*Preliminary Consultation*  
**MONTGOMERY COUNTY HISTORIC PRESERVATION COMMISSION**  
**STAFF REPORT**

<b>Address:</b>	1 Quincy St., Chevy Chase	<b>Meeting Date:</b>	12/5/2018
<b>Resource:</b>	<b>Outstanding Resource</b> Chevy Chase Village Historic District	<b>Report Date:</b>	11/28/2018
<b>Applicant:</b>	B. Francis Savi <b>(John Kowalski, Architect)</b>	<b>Public Notice:</b>	11/21/2018
<b>Review:</b>	Preliminary Consultation	<b>Tax Credit:</b>	N/A
<b>Case Number:</b>	N/A	<b>Staff:</b>	Michael Kyne
<b>PROPOSAL:</b>	Partial demolition and construction of an elevator tower

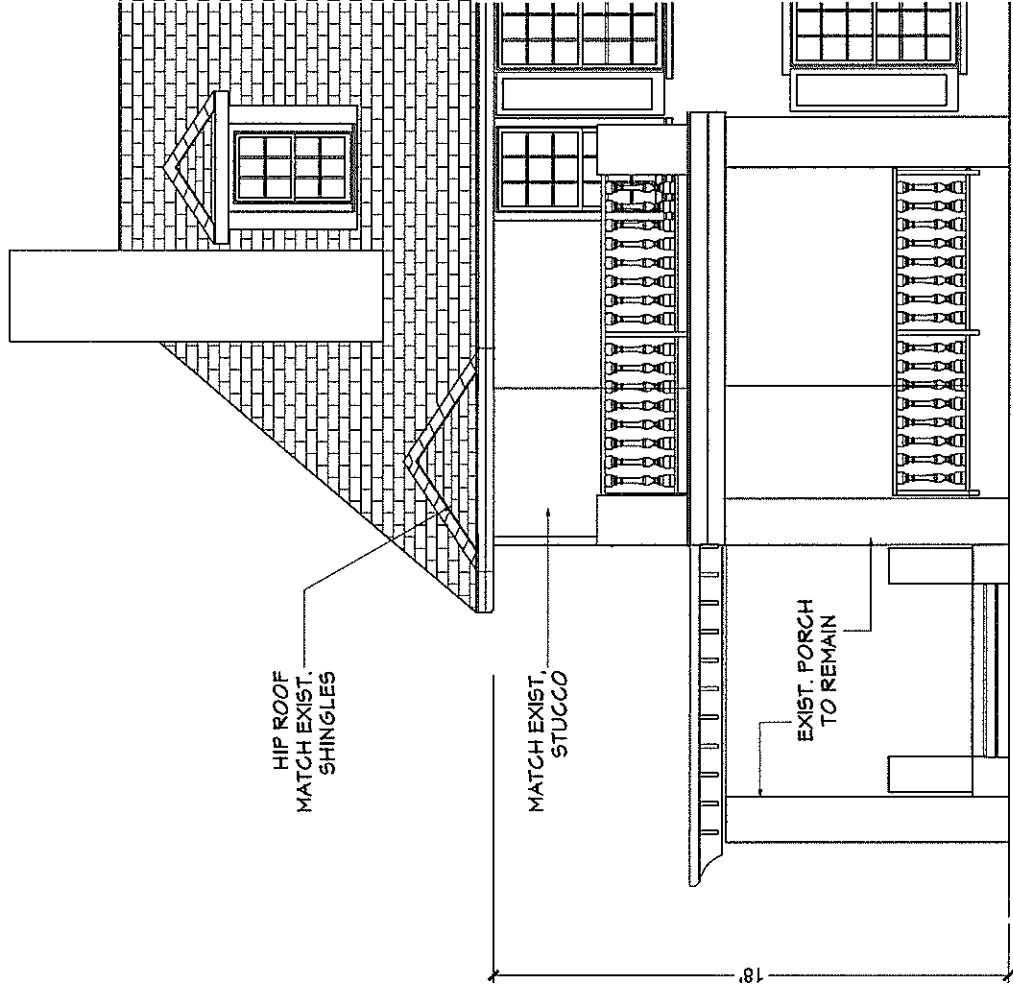
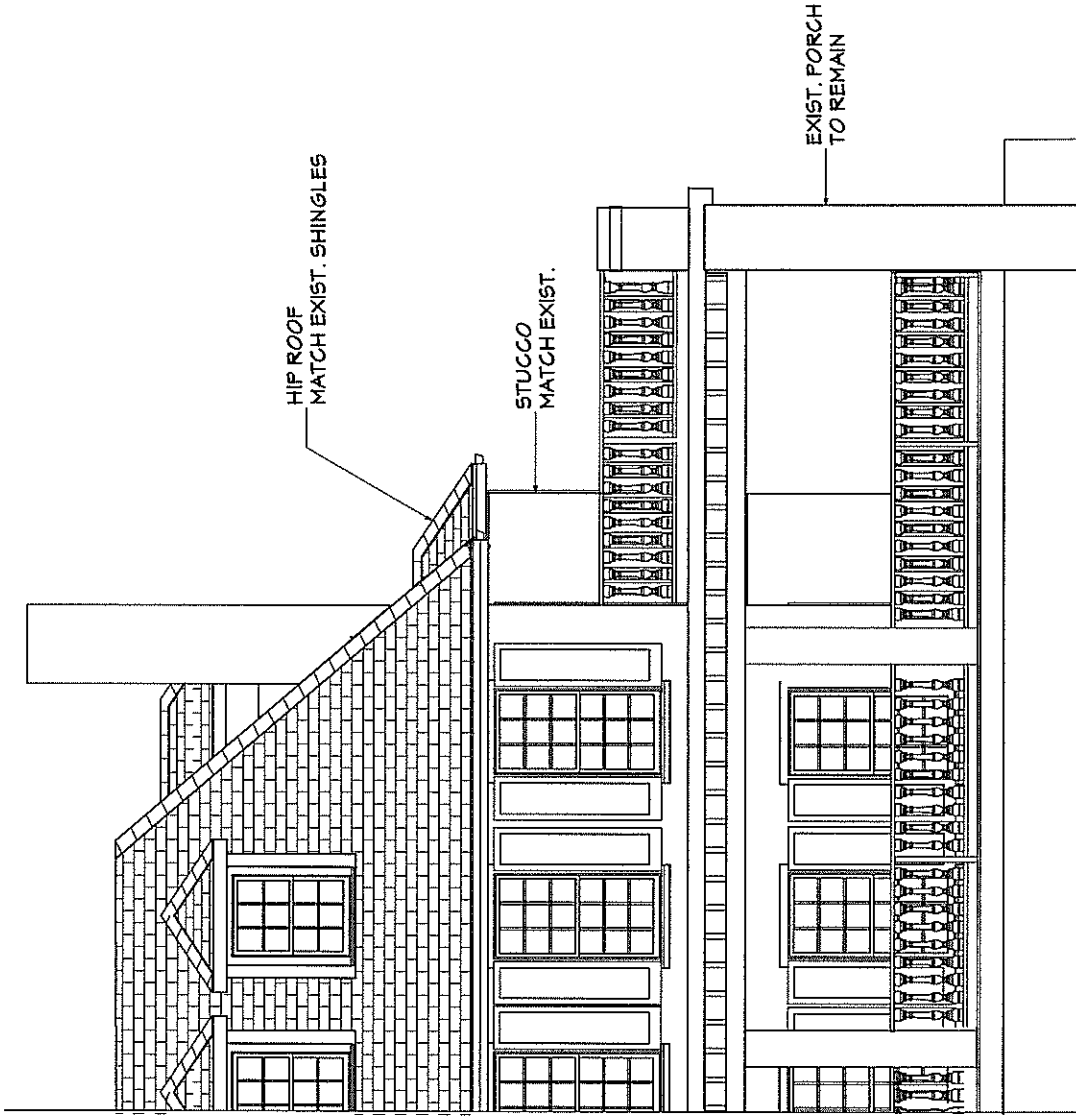
As noted, the proposed elevator tower will be constructed on the front/right corner of the historic house, and, despite the house's deep setback from both Connecticut Avenue and Quincy Street, will be visible from the public right-of-way. This is clearly demonstrated by the submitted photographs. The proposed alterations would substantially alter the front of the structure, and, due to the visibility of the house from the public right-of-way, the proposal should be reviewed with strict scrutiny. The *Guidelines* state the following regarding strict scrutiny:

Staff finds that the proposed elevator tower will compromise the integrity of the historic house by removing character defining features, such as the railing, window, and French doors, and by altering the perceived shape and massing from the surrounding streetscape. This is inconsistent with the *Guidelines* and with *Standards #2* and *#9*, which stress that character-defining features and historic materials should not be removed, altered, or destroyed. It is also inconsistent with *Standard #10*, which stresses that additions should be constructed so that if removed in the future the essential form and integrity of the historic house would be unimpaired.

Staff recommends that the proposed elevator tower not be approved, and that the applicant explore compatible and appropriate alternatives, such as an entirely interior elevator tower or an elevator tower in a more appropriate location that will not be visible from the public right-of-way and will not require the removal or alteration of historic materials.

- Staff recommends that the proposed elevator tower not be approved.
- Staff recommends that the applicant explore appropriate and compatible alternatives, as discussed above.
- Staff recommends that the applicant make any revisions based upon the HPC's comments and return for a second preliminary consultation.
